North Tower Response to OSD and Metro DRP Feedback

DRP 7 North Tower

SMMP—ISD

18 December 2018

Strategies

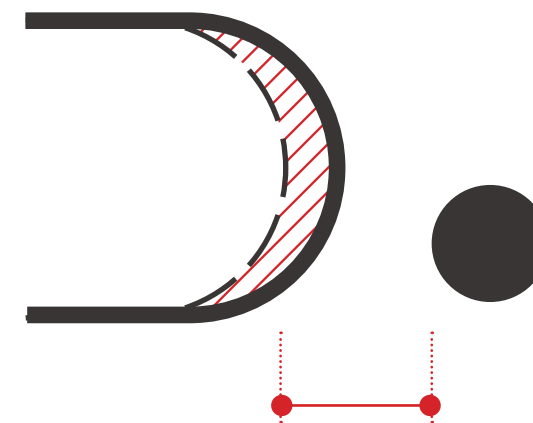
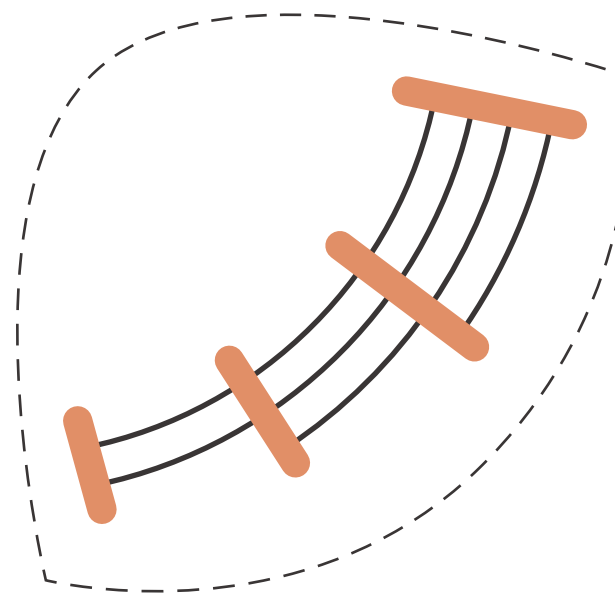
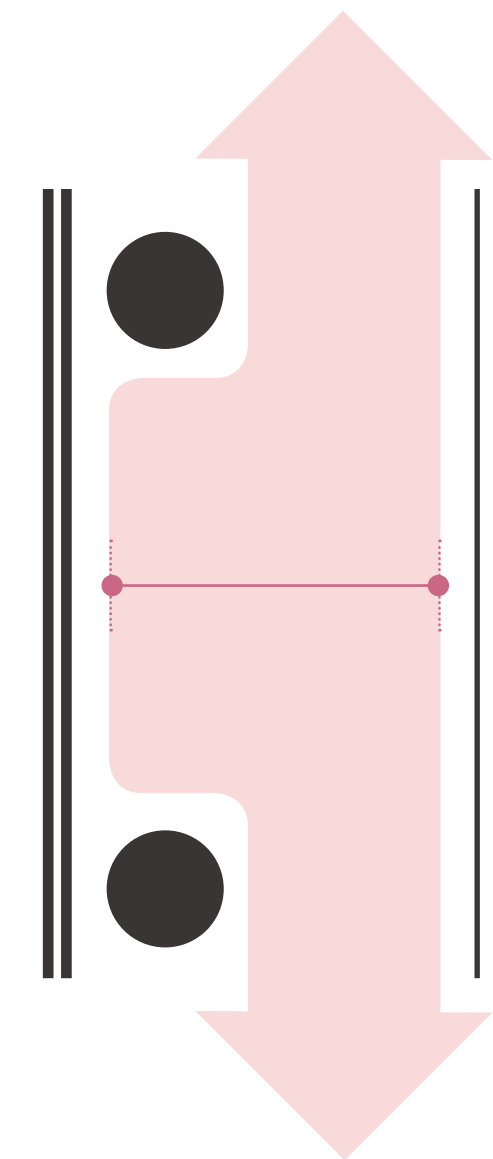
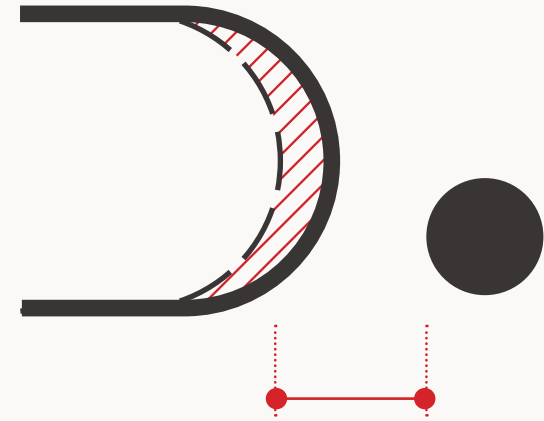
- C** “While the proposal for stairs creates a more welcoming corner entrance, the building’s interface with Hunter Street is unresolved. We are **concerned about the spaces between the building and columns** on the northern elevation.
- A** We also emphasise the need for the **disabled access** off Elizabeth Street, which occurs between columns, **to be made as generous as possible.**”
- D** “While we support the awning proposal, we recommend it be lowered as far as possible to improve weather protection, particularly that portion of the awning which is raised to mark the entrance to the through site link.”

- B** “Further design refinement is required to **address how the seating steps meet the column on the northern elevation.**”
- C** We recommend **consideration of opportunities for public seating** between the columns on the northern elevation to Hunter Street.”
- D** “Further design refinement is required to **ensure the awnings which mark entrances to public and private spaces are differentiated.**”

- B** • The building’s interface with Hunter Street still requires improvement, particularly to **avoid the sections of feathered steps.**
- C** • The **areas between the columns and footpath to Hunter are not optimised** and lack a positive civic presence.
- A** • Access to the **disabled entry** on Elizabeth Street needs to be as **generous in width as possible.**”
- D** “The Panel encourages further review of the awning at the entry to the mid-block connection to **ensure that the station entry has an appropriate clarity and identity.**”

- B** “Further design development to **avoid feathered steps** at the Elizabeth Street entry and to provide the appropriate civic response along Hunter Street.”
- D** “Further design review of the awning above the entry to the mid-block connection on Elizabeth and Castlereagh Streets to ensure the awnings serve their intended purpose of weather protection and **give the station entry sufficient clarity / visual identity.**”

A CORE REPLANNING

B INTEGRATION & DECLUTTERING

C ACTIVATION

D WAYFINDING

DRP 3 — May 2018

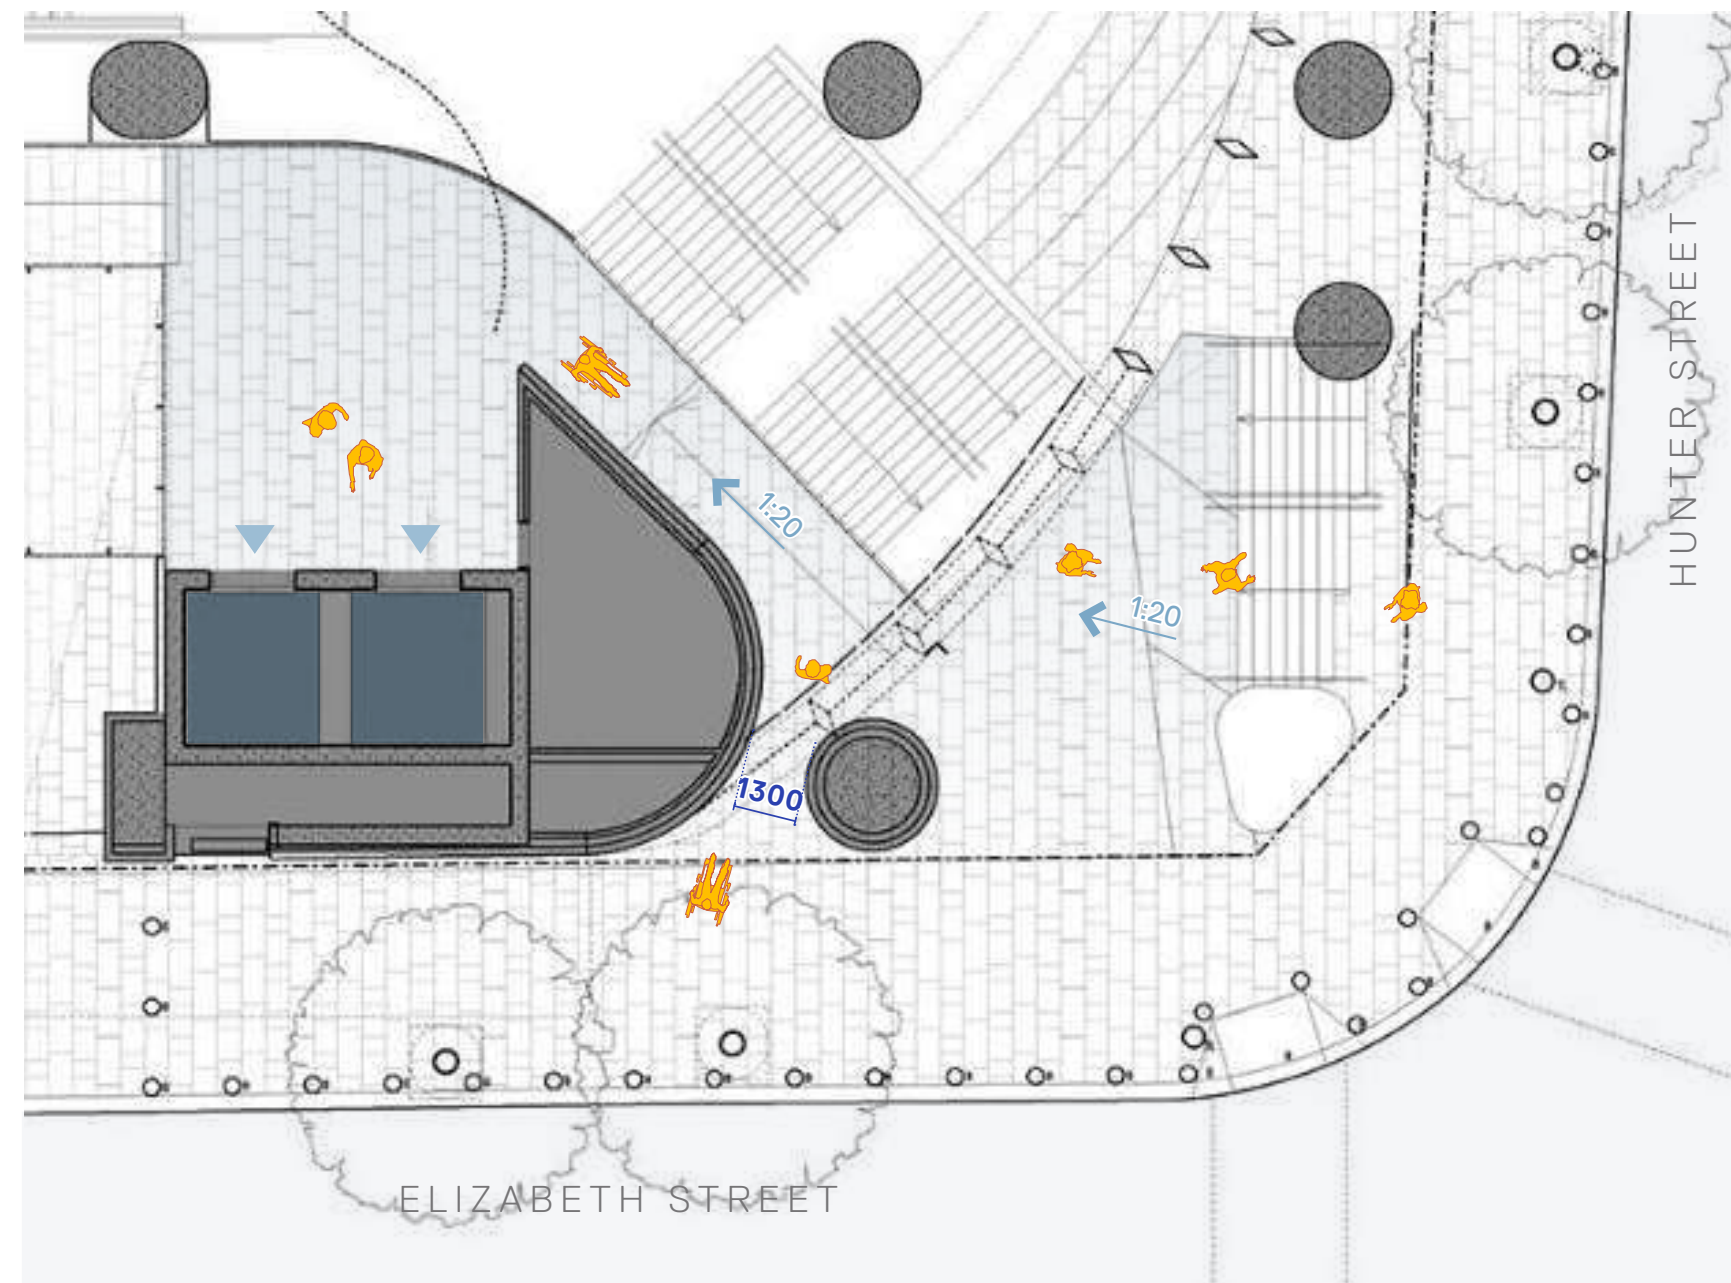
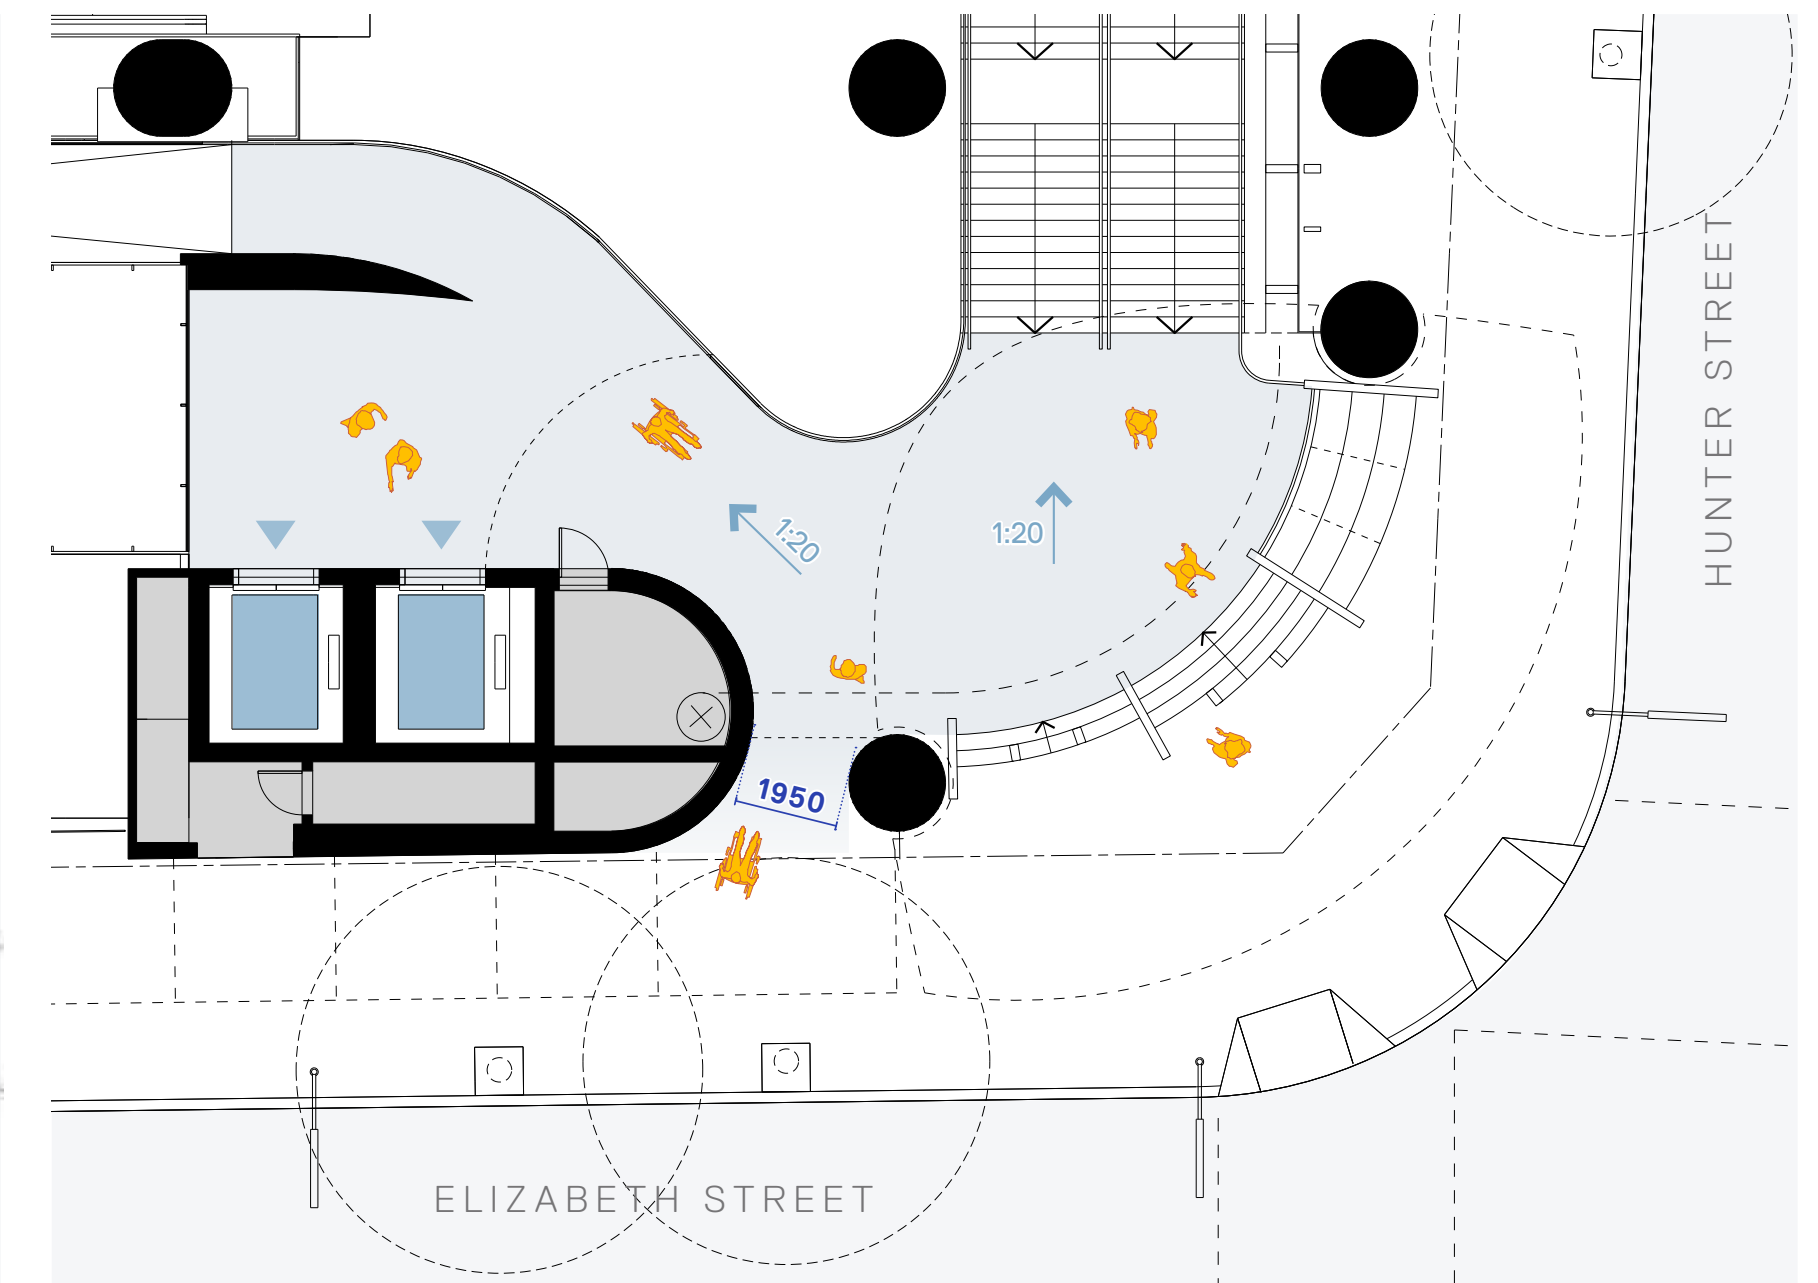
OSD DRP comment:

*“We also emphasise the need for the disabled access off Elizabeth Street, which occurs between columns, to be made **as generous as possible.**”*

Station DRP comment:

*“Access to the disabled entry on Elizabeth Street needs to be **as generous in width as possible.**”*

Current proposal
